SUBJECT: WESTINGHOUSE RESPONSES TO NRC REQUESTS FOR ADDITIONAL
INFORMATION ON THE AP600 PRHR HEAT EXCHANGER

WESTINGHOUSE RESPONSES TO RAI 952.94 (Revision 1)

Question OI 21.3.3-1

Re. PRHR Heat Exchanger

Figure 3
PRHR Tube Spacing

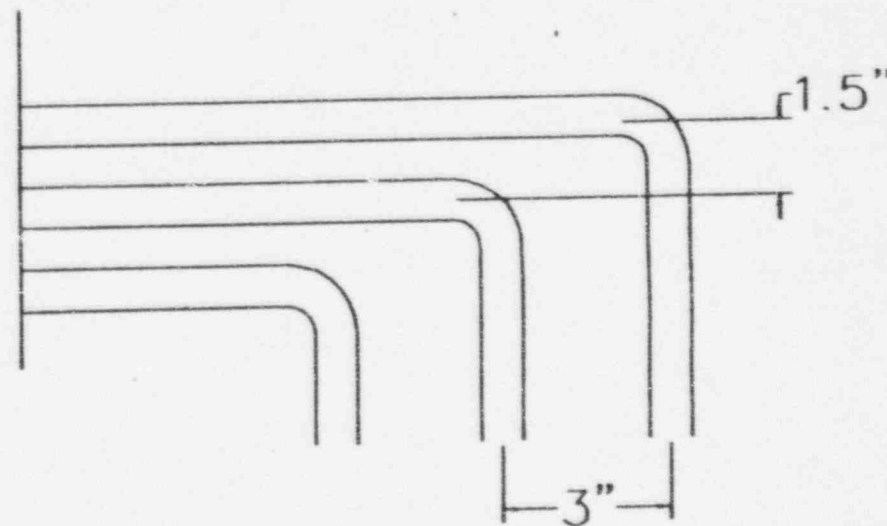
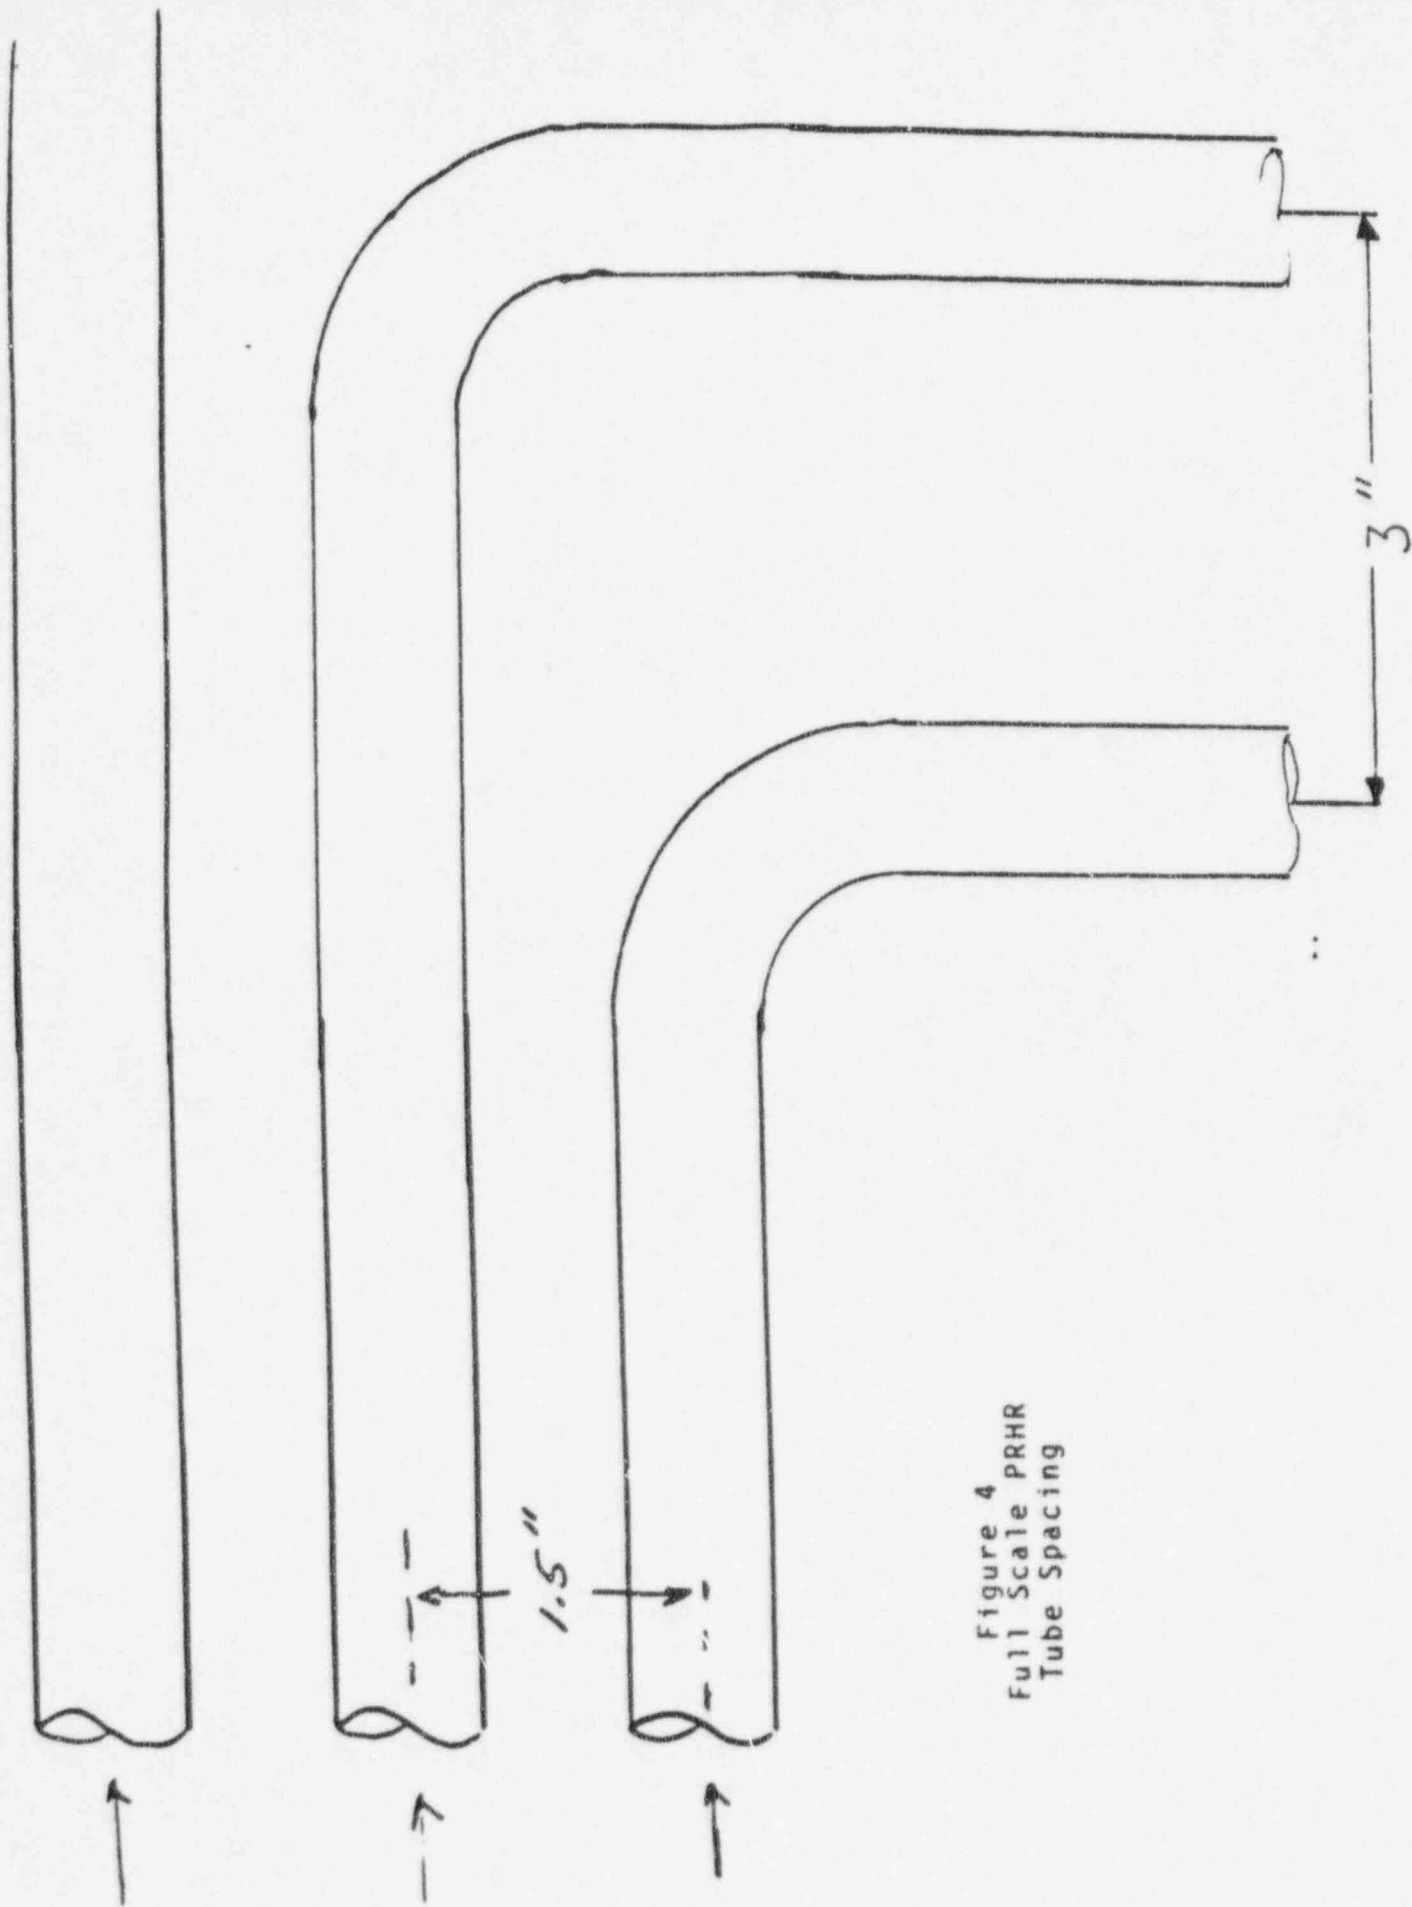
Westinghouse must provide a detailed justification on the applicability of the straight tube passive residual heat removal heat exchanger (PRHRHX) test data to the new "C"-tube configuration.

The PRHR tube geometry is an important parameter in evaluating the heat exchanger performance and in determining if the different regions of the exchanger could experience critical heat flux and would become vapor blanketed. Figures 3 and 4 show the different tube pitches for the tube-to-tube distances within a given row of tubes, and the row-to-row distances for the different rows both in the vertical and horizontal direction. As the figures indicate, the tube pitch/diameter ratio is 2 for tube-to-tube spacing within a given row. The row-to-row pitch/diameter ratio is 4 for the vertical section and 2 for the horizontal section. This spacing is very open as compared to typical kettle boilers (Reference 21.3.3-2) or rod bundles where the pitch/diameter ratio is usually 1.3. The more open the tube lattice, the smaller the tube-to-tube interaction will become as vapor is generated in the IRWST due to the heat transfer from the PRHR.
